MANUAL CHANGES

Model Number: 8690B
 Date Printed: May 1972
 Part Number: 08690-90018

This supplement contains important information for correcting manual errors and for adapting the manual to instruments containing improvements made after the printing of the manual.

Page 7-3, Figure 7-2:

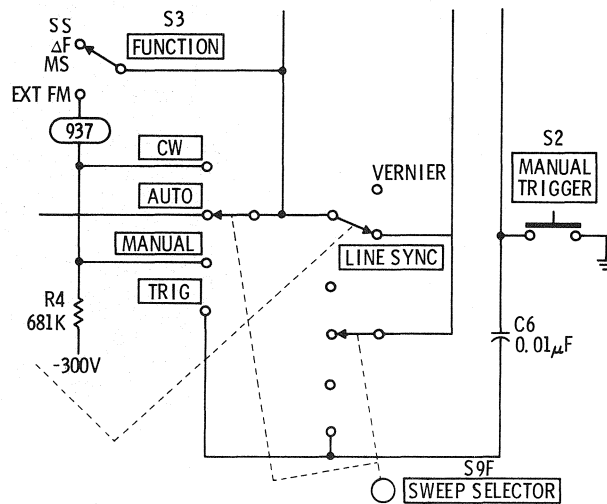
Change switch labeling as shown below:

P/O Figure 7-3. Frequency Control Section Reciprocal Amplifier

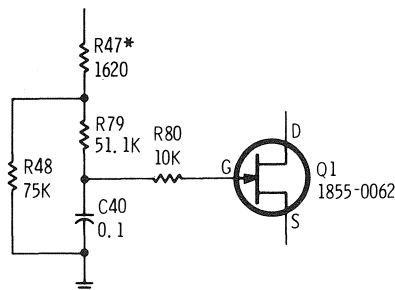
- Change the A3 Assembly Component Identification Photo indicate R77 and R78 designations are swapped.
- Change F1 to 0.032A
- Change the A3 Assembly Resistor Reference Designations to read R30-34, 40-45, 47-80.
- Change the circuitry of A3Q1 as shown in the attached drawing:

Component Identification, Assembly A9

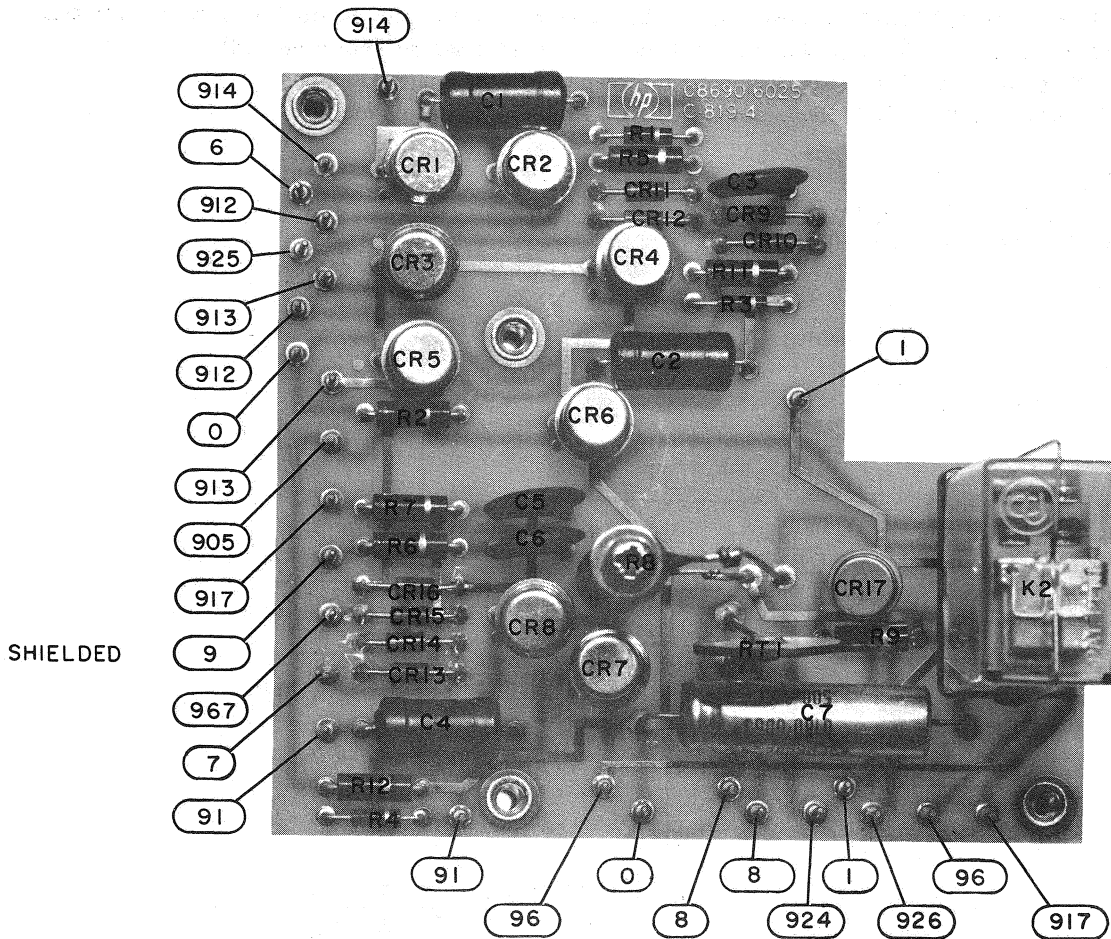
Substitute the attached A9 Component Identification board for that shown in the 8690B Manual.

Figure 1. Component Identification, Assembly A8 (Part of Change 1)

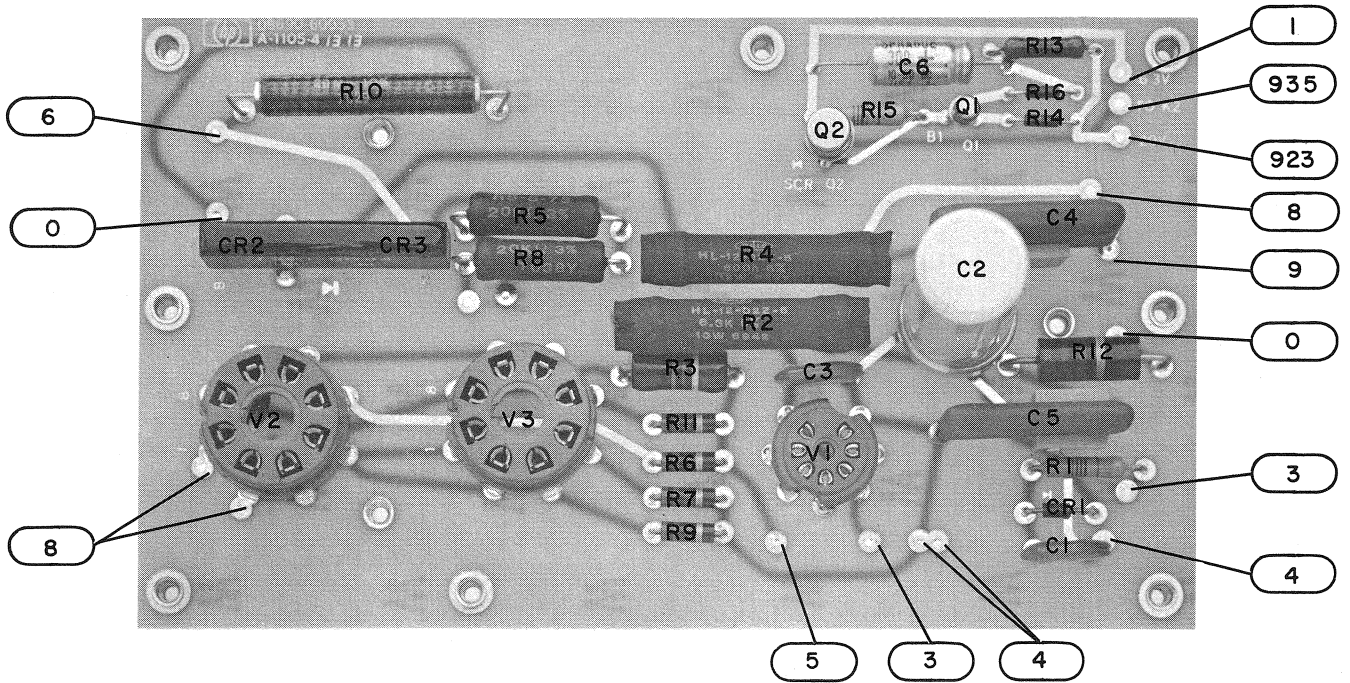
Substitute the attached A8 Assy, Component Identification board photo (Figure 1) for the photo shown in the 8690B Manual.

Figure 2. Component Identification, Assembly A14 (Part of Change 2)

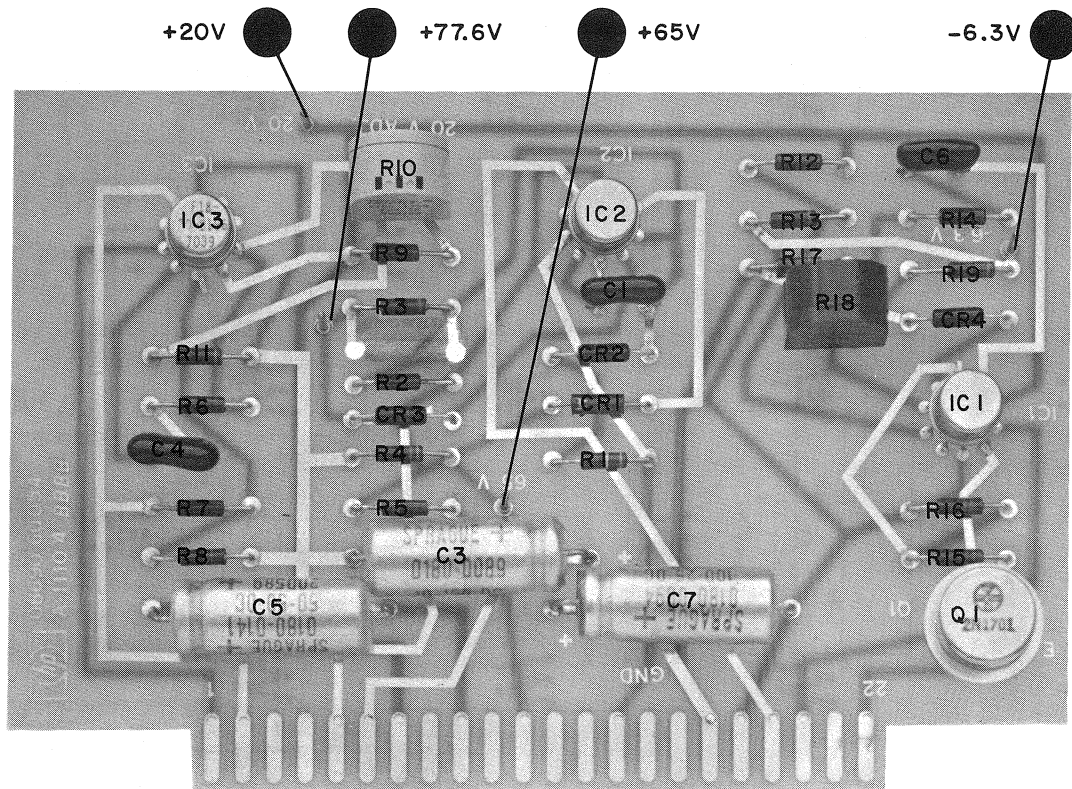
Substitute the attached A14 Assy board photo and schematic (Figures 2 and 3) for those shown in the 8690B Manual.

Figure 4. Component Identification, Assembly A4 (Part of Change 5)

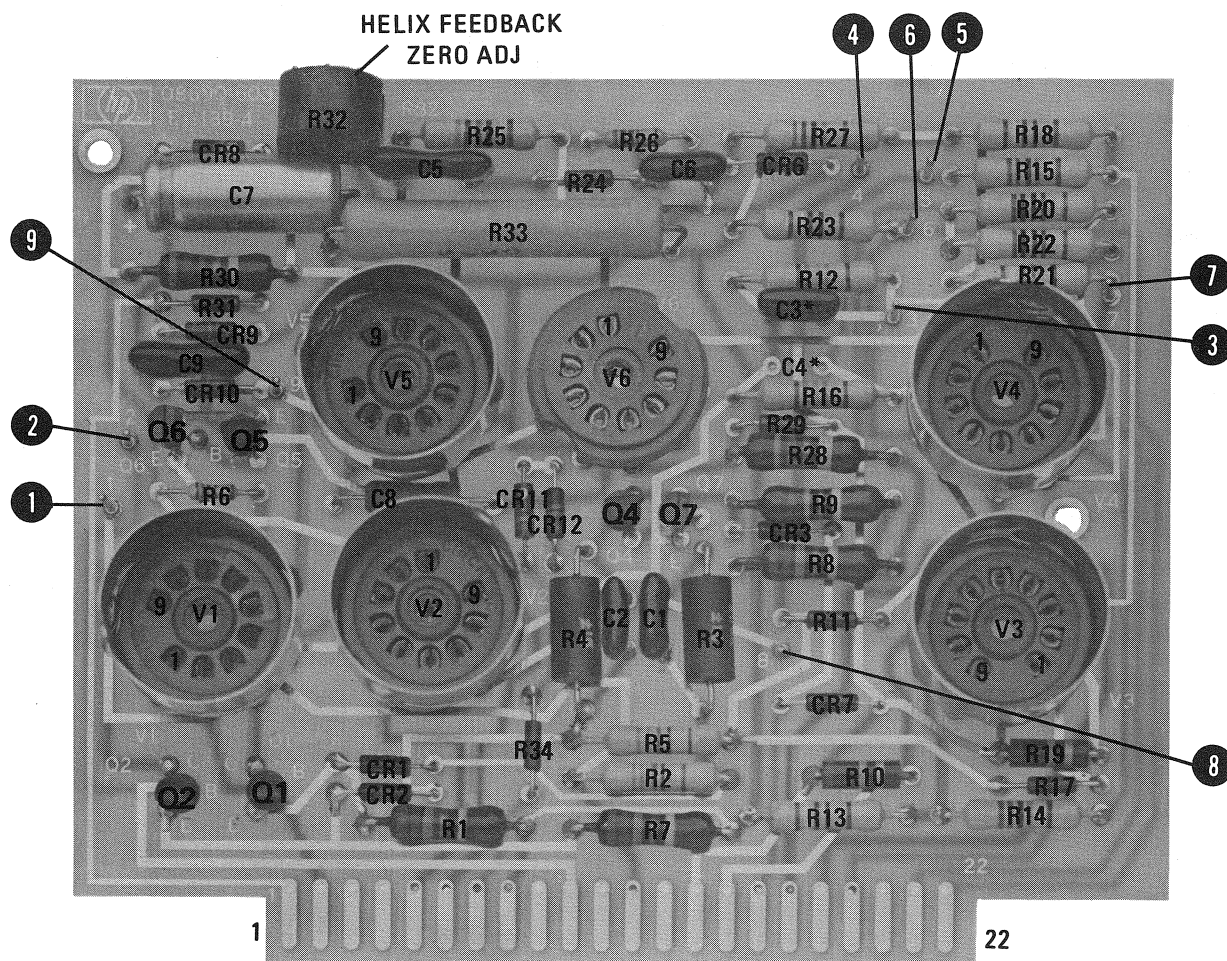
Add diode A4CR12 in series with zener diode A4CR11. Connect cathode of A4CR12 to ground, and anode to A4CR11.

Figure 5. Component Identification, Assembly A3 (Part of Change 1)

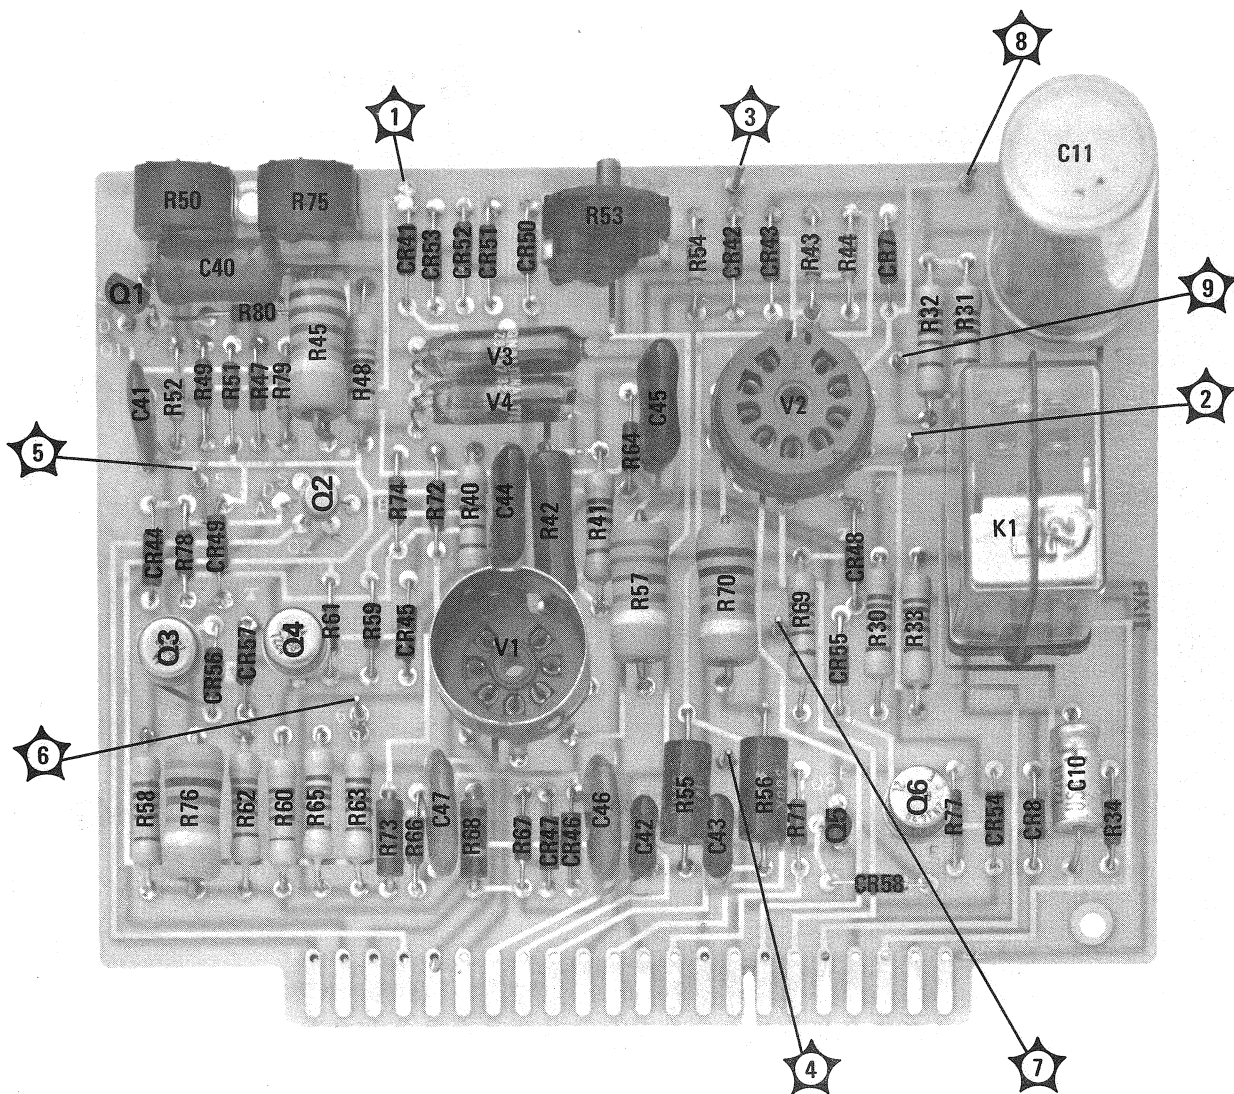
Substitute the attached Component Identification Assembly A3 board photo (Figure 5) for the photo shown in the manual.

Figure 6. Partial Schematic Diagram of the Power Supply Section Showing Thermal Switch S15
(Part of Change 11)

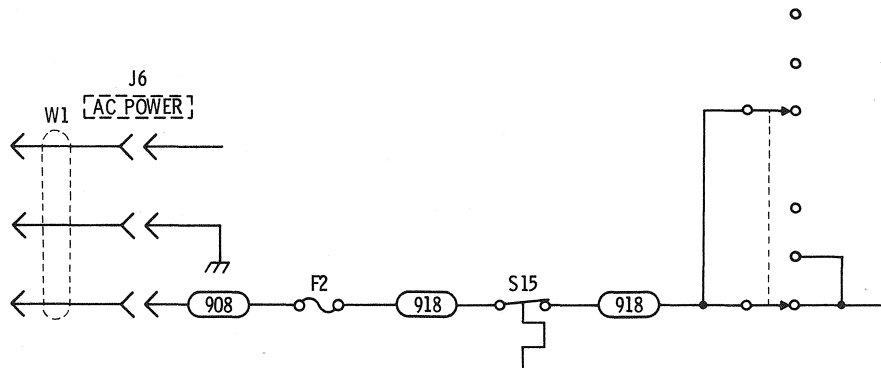
Add thermal switch S15 to schematic diagram of Power Supply Section as shown in Figure 6.
